III. Revisions, Clarifications, and Corrections to the Draft EIR

This section of the Final EIR provides changes to the Draft EIR that have been made to revise, clarify, or correct the environmental impact analysis for Transportation Communication Network (the Project). Such changes are a result of public and agency comments received in response to the Draft EIR and/or additional information that has become available since publication of the Draft EIR. The changes described in this section do not result in the Project creating any new or increased significant environmental impacts.

This section is divided into three parts: Section III.A, General Corrections and Revisions to the Draft EIR; Section III.B, Corrections and Additions to Draft EIR Sections and Appendices; and Section III.C, Effect of Corrections and Revisions.

Figure II-6
Conceptual Rendering of Freeway Facing TCN Structure

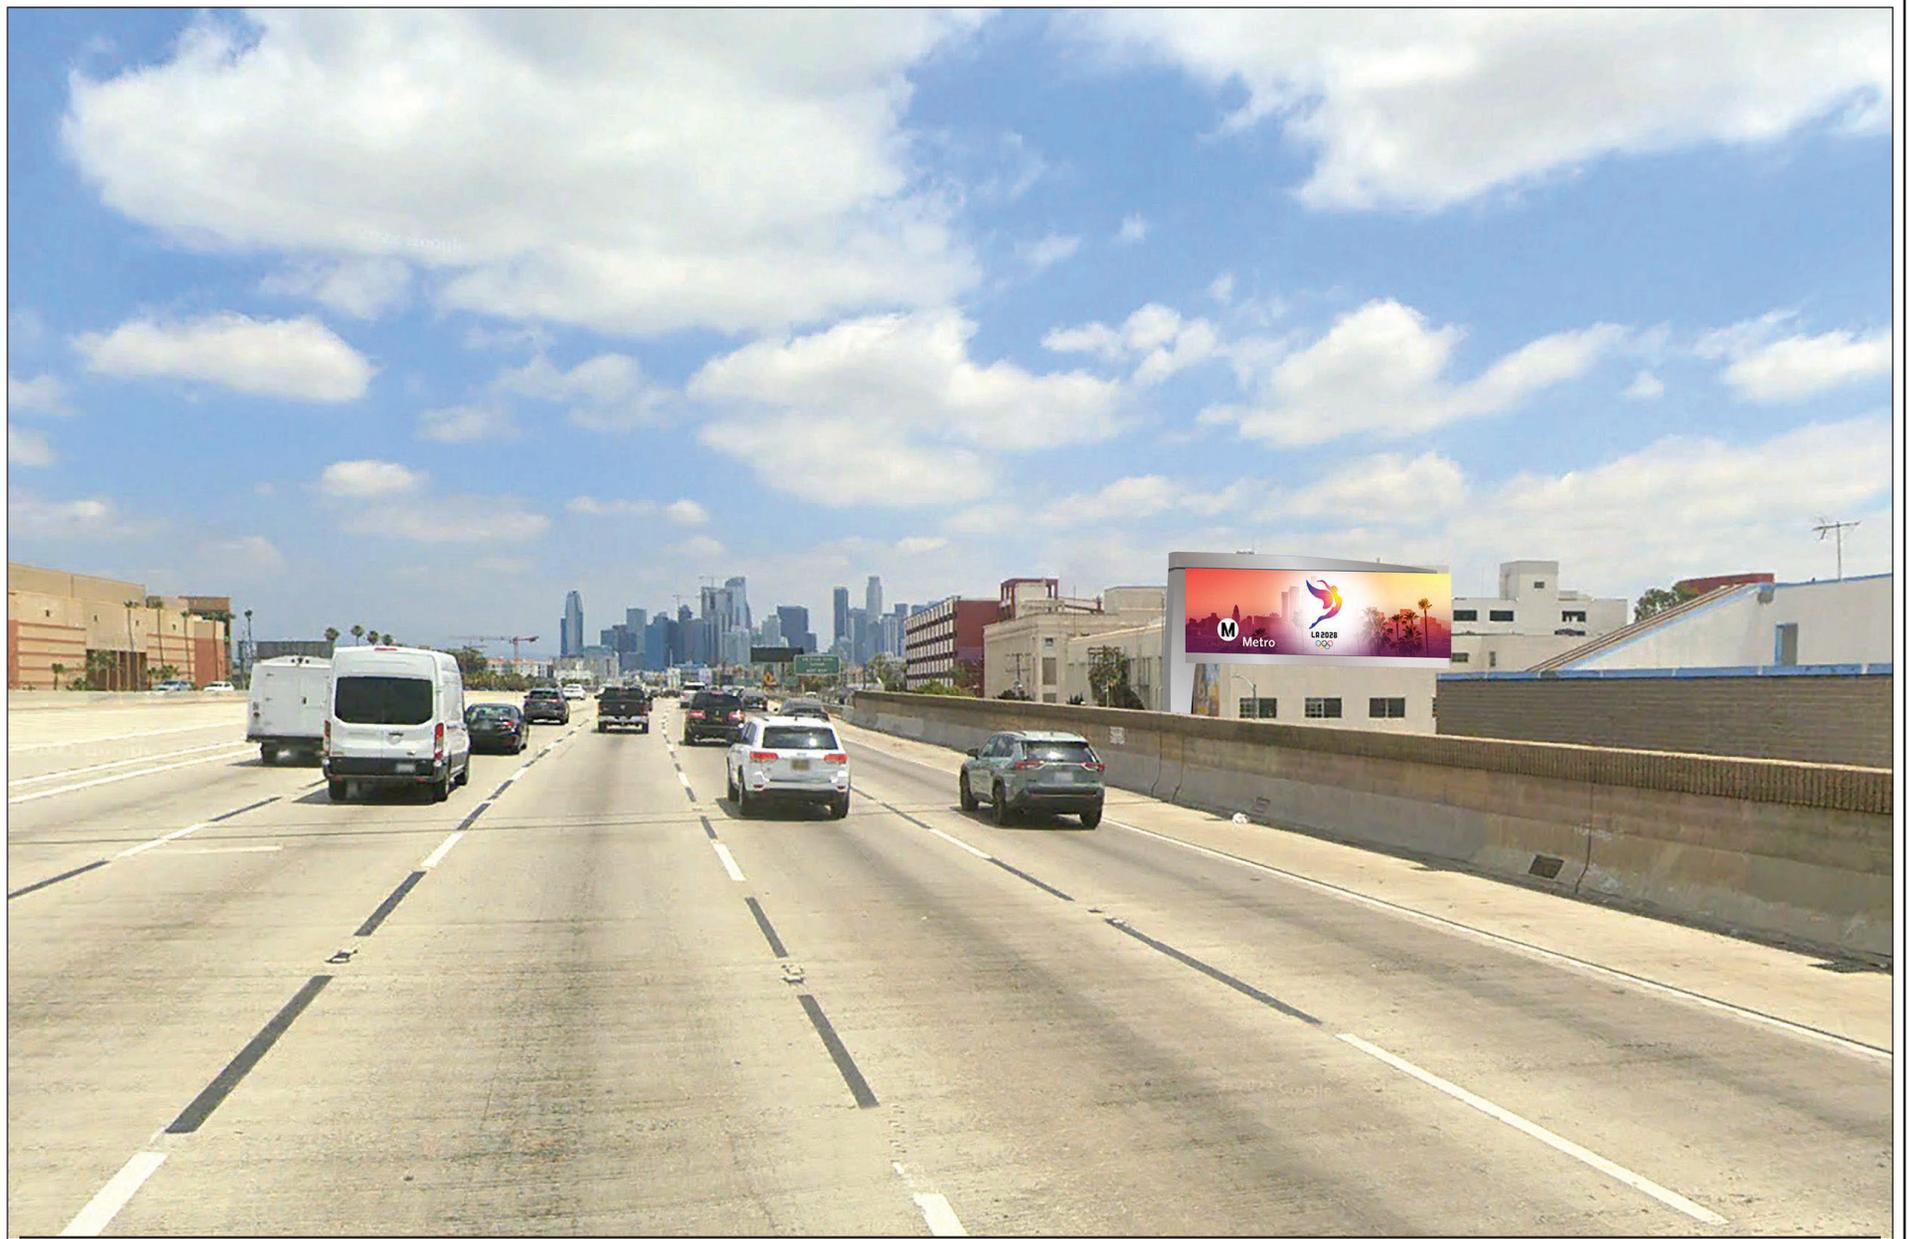
Two figures, as well as corresponding figure references, were added in response to comments for clarification of the conceptual design of TCN Structures.

Chapter II, subsection C, Design and Location of the TCN Structures, page II-7 revise the last paragraph as follows and add Figures II-6 and II-7.

Refer to Table II-1 and Table II-2 on pages II-8 and II-10 and Figure II-1 through Figure II-3 on pages II-12 through II-14, respectively, for a listing of the proposed locations, digital display square footage, number of digital displays per TCN Structure, and dimensions of the digital displays. Conceptual renderings are included as Figure II-6 and Figure II-7 on pages III-5 and III-6 of the Final EIR, are for informational purposes only and provide a realistic estimation of what the TCN Structures may look like within the City.
